REMARKS

Amendments to the Specification and Drawings

IN THE DRAWINGS:

Fig. 16

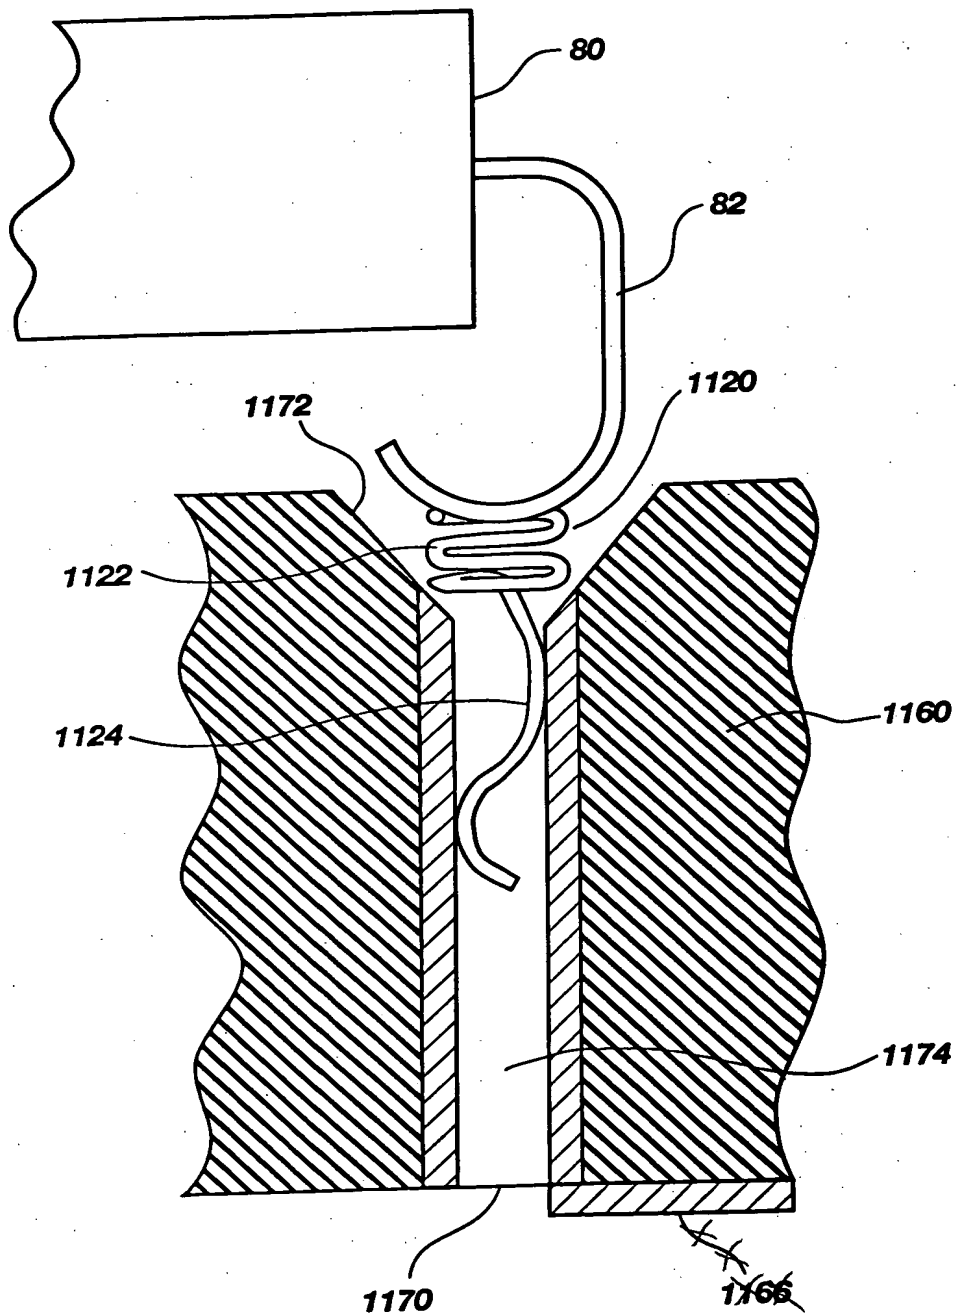
Applicant proposes to amend FIG. 16 of the drawings by deleting reference numeral "1166" and associated lead line. A copy of FIG. 16 with the proposed deletion marked in red is appended to this paper, as well as a replacement sheet with FIG. 16 as proposed to be amended.
